**APPLICATION NO. A/NE-TK/837 FOR PERMISSION  
UNDER SECTION 16 OF THE TOWN PLANNING ORDINANCE**

Annex 1 - Response to Comments Table

Section 16 Application for Temporary Public Vehicle Park (Private Cars Only) with Ancillary Electric Vehicle Charging Facilities and Ancillary Solar Panels and Associated Filling of Land for a Period of 3 Years at Lot No. 241 in D.D. 23 at Ting Kok, Tai Po, New Territories

Annex 4 : Swept Path Analysis

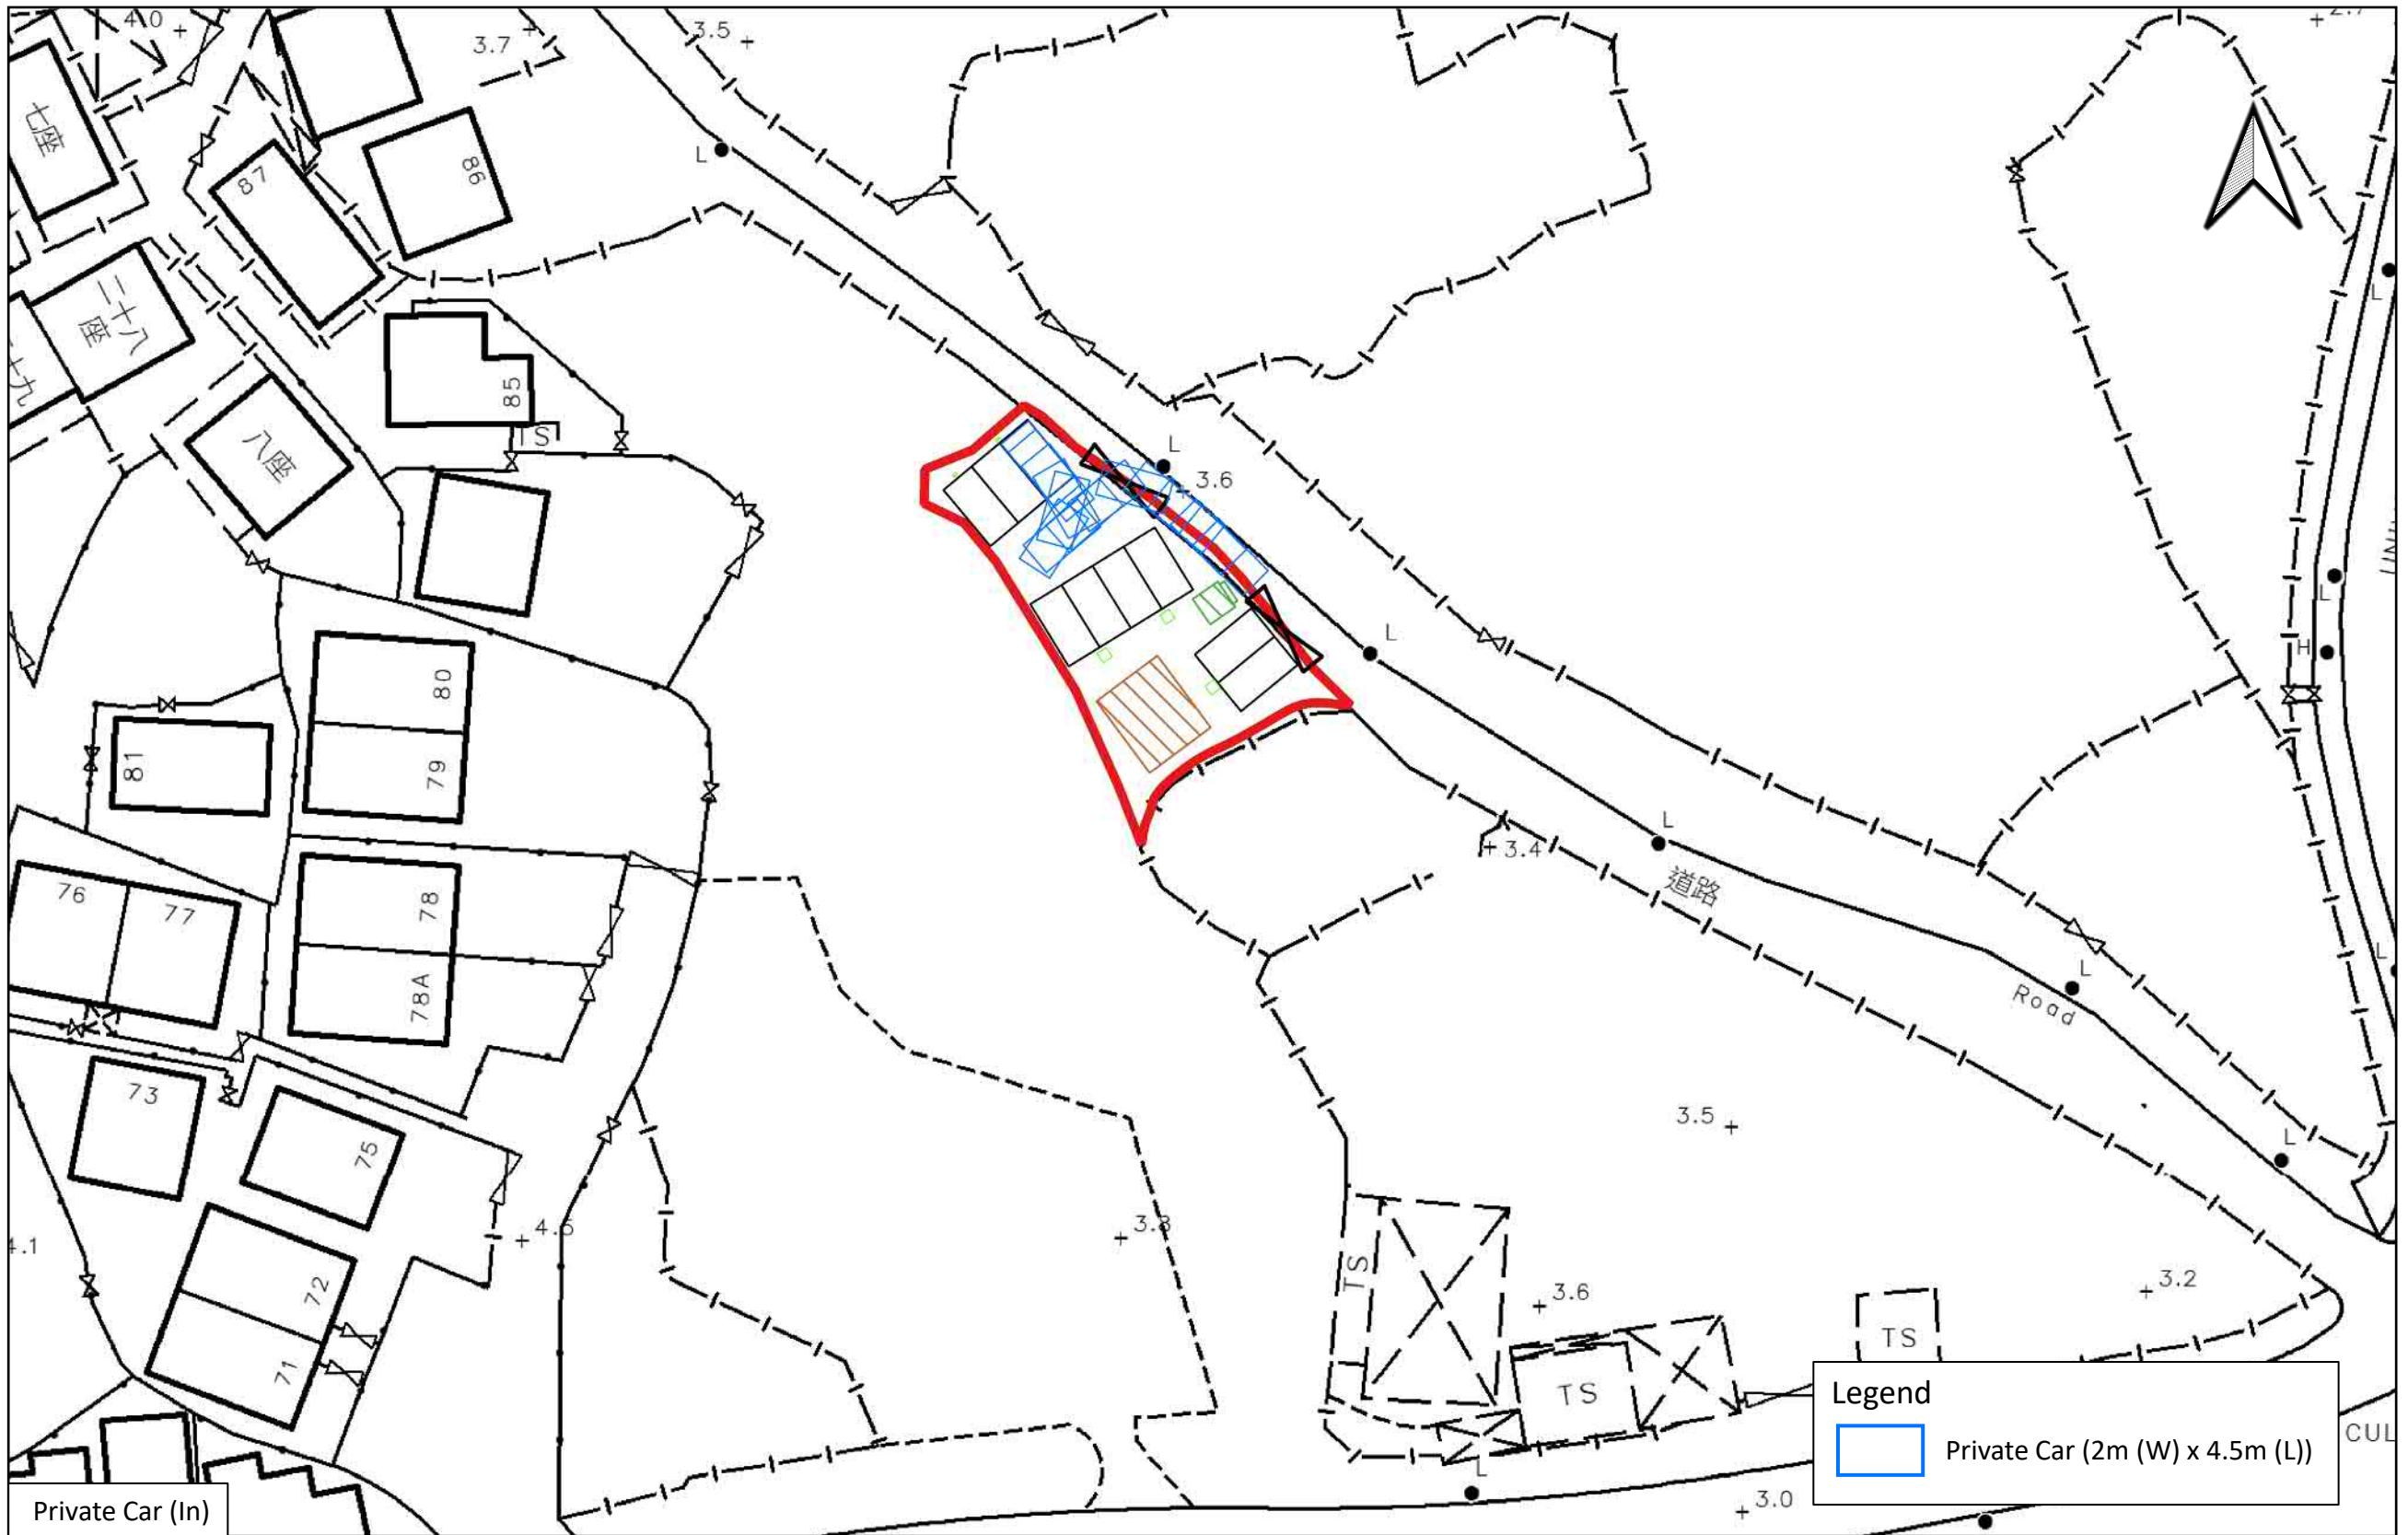
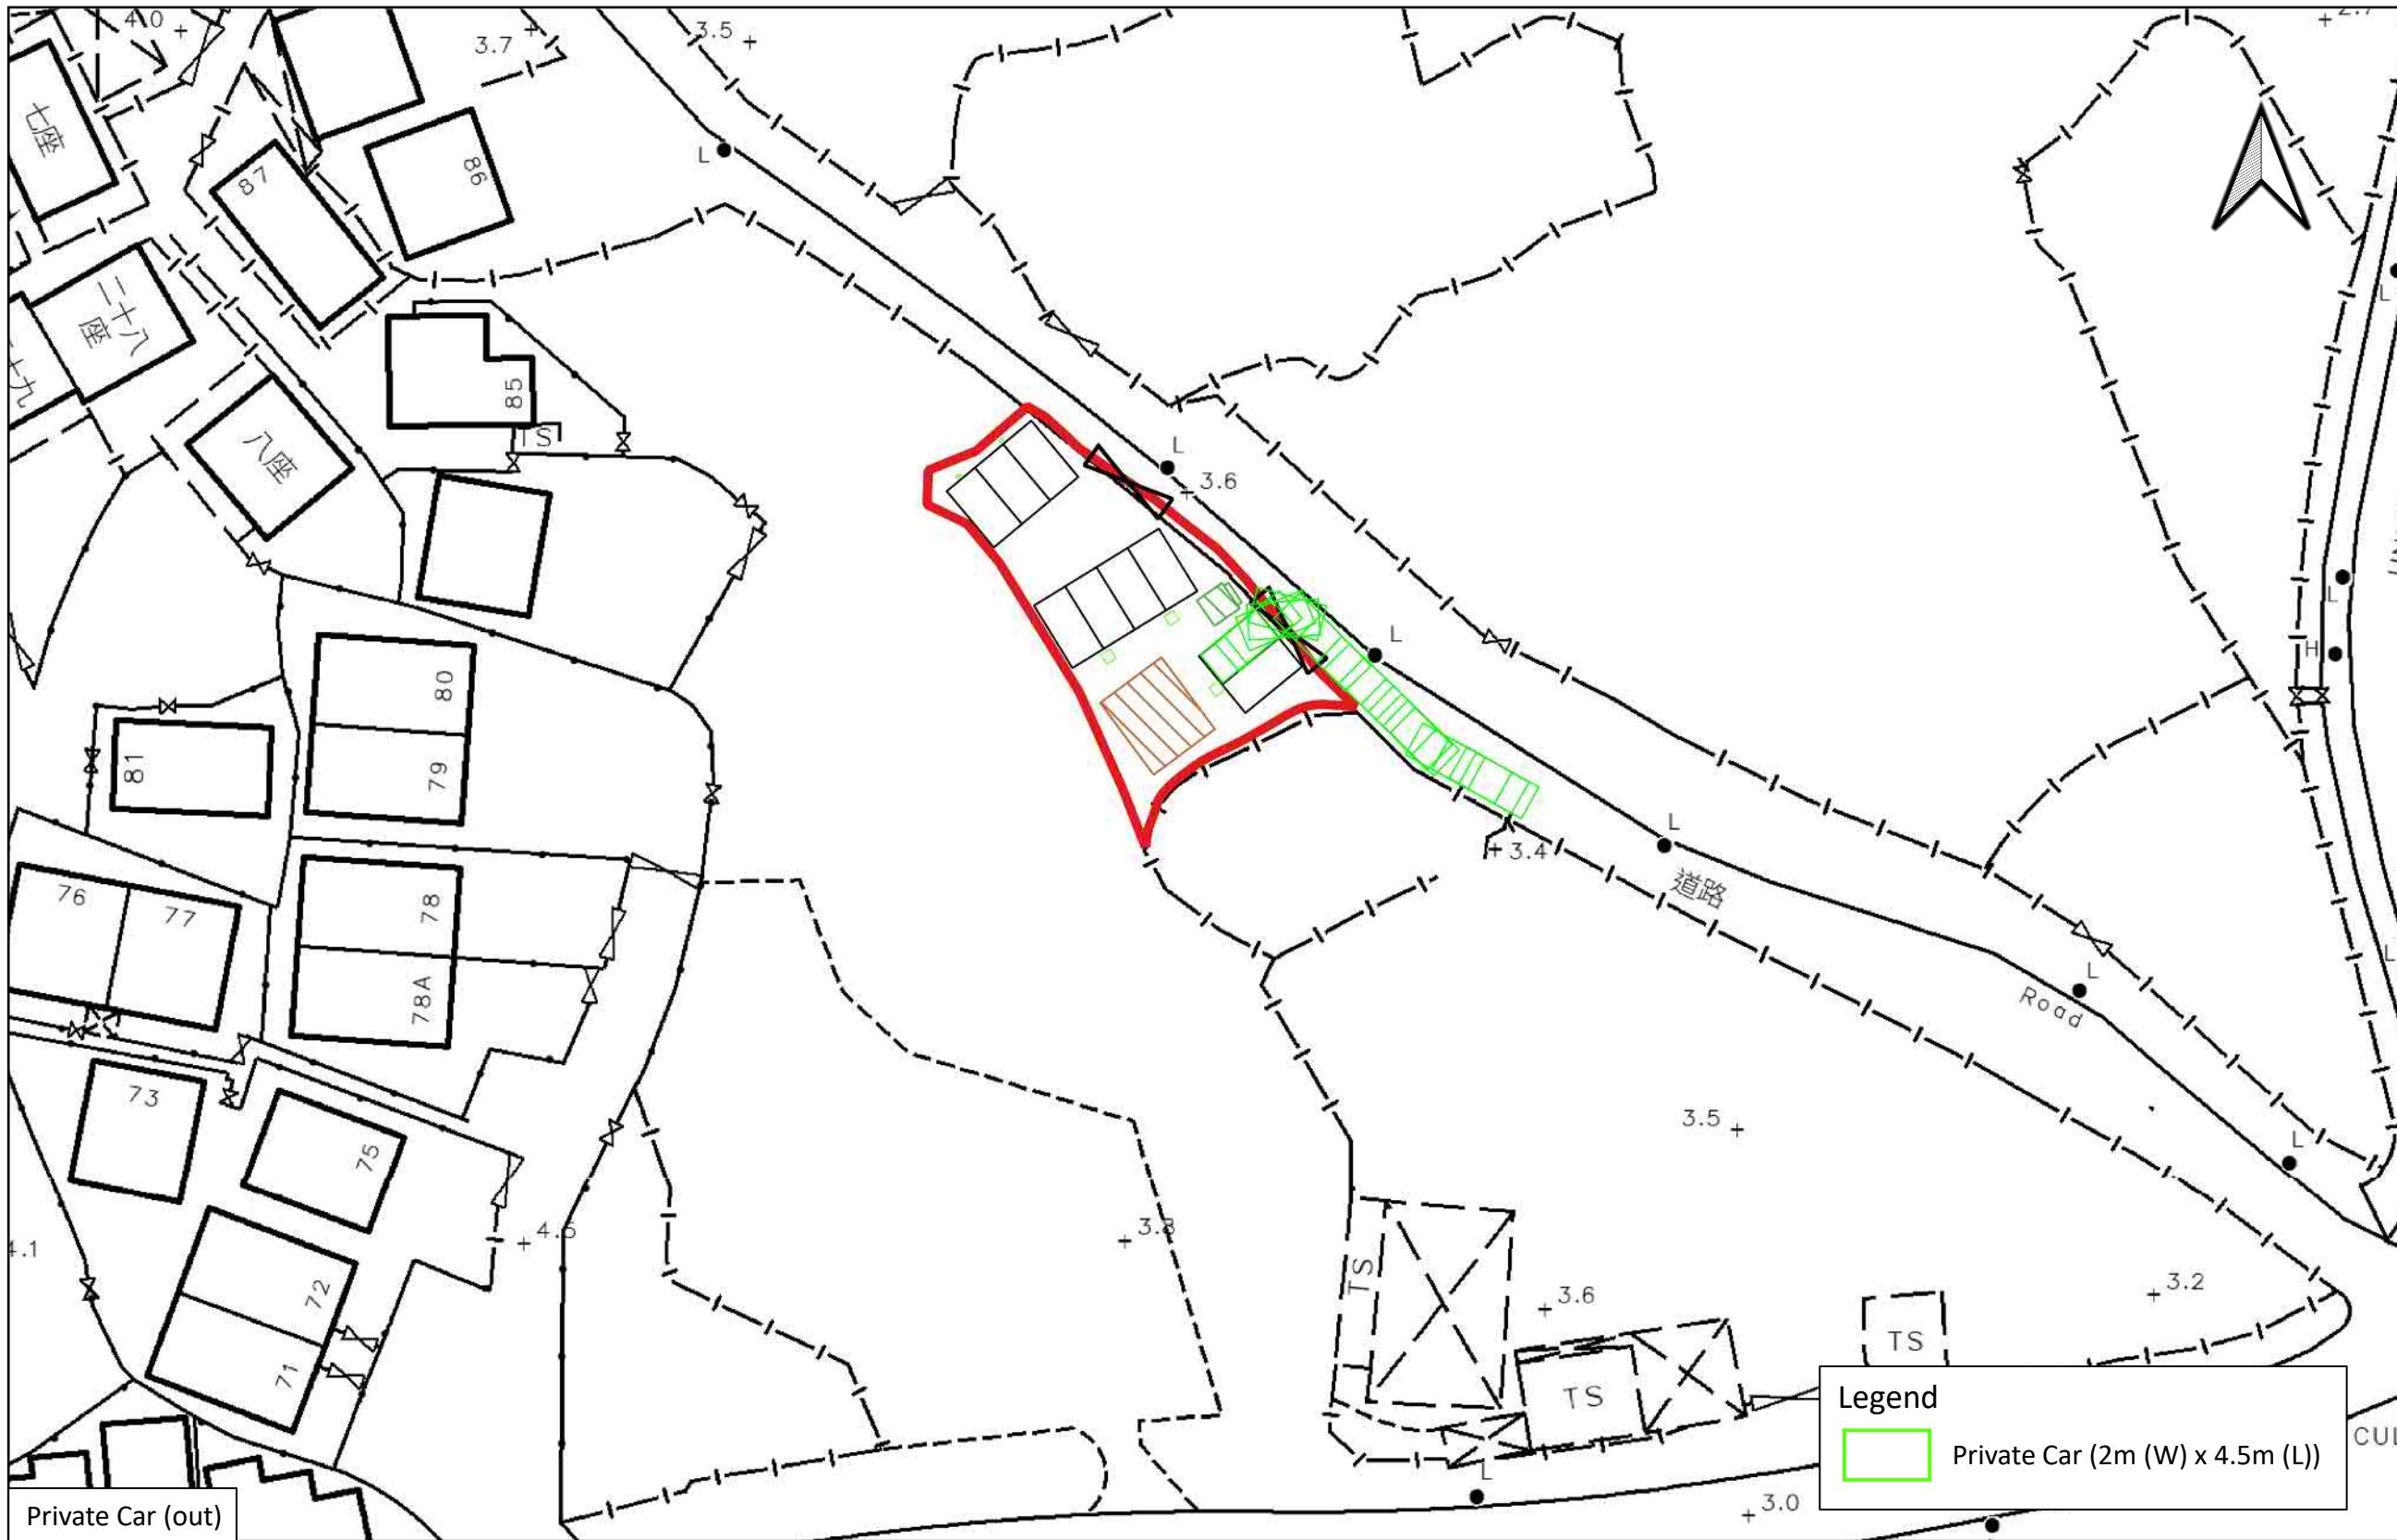
operations of electric taxis and achieve the aforesaid target. In this connection, we recommend that the applicant consider installing some fast chargers with a rated output power of 100kW or higher at the proposed site and open up a certain number of charging spaces for electric commercial vehicles for use, e.g. electric taxis and electric light goods vehicles.	
<b>2</b> <i>Comments from Transport Department received on 22 July 2025</i>		
d	For vehicular access: (i) The number of vehicular access for a development site shall be limited to one from traffic management viewpoint. The applicant shall review the number and location of the vehicular access.	Well noted with thanks.
e	(ii) We note from the swept path analyses that the private car will clash with the existing lamppost. The applicant is reminded to review the locations of access gate and other street furniture to avoid conflicts.	Noted.  The swept path analysis in <b>Annex 4</b> has been revised and it is illustrated that there will be no conflict with street furniture.

f	(iii) The two parking spaces directly in front of the southern access create safety concerns due to limited visibility of drivers and increase risk of accidents when reversing.	Well noted.  It is assumed that vehicles driving out from the Application Site will stop at the southern access and view both sides carefully due to the level difference. Based on the sightline analysis as shown in <b>Annex 5</b> , it is revealed that adequate visibility could still be provided for vehicles both driving in from Tung Tsz Road and driving out from Application Site, and they will not be affected by the Proposed Development and its vehicular access.
g	For the car park layout: (i) The applicant shall demonstrate that there are sufficient spaces for maneuvering of vehicles within the areas, in particular for the parking	Noted.  The swept path analysis in <b>Annex 4</b> has been revised to ensure that there is sufficient space for vehicle to maneuver within the site, particularly for the
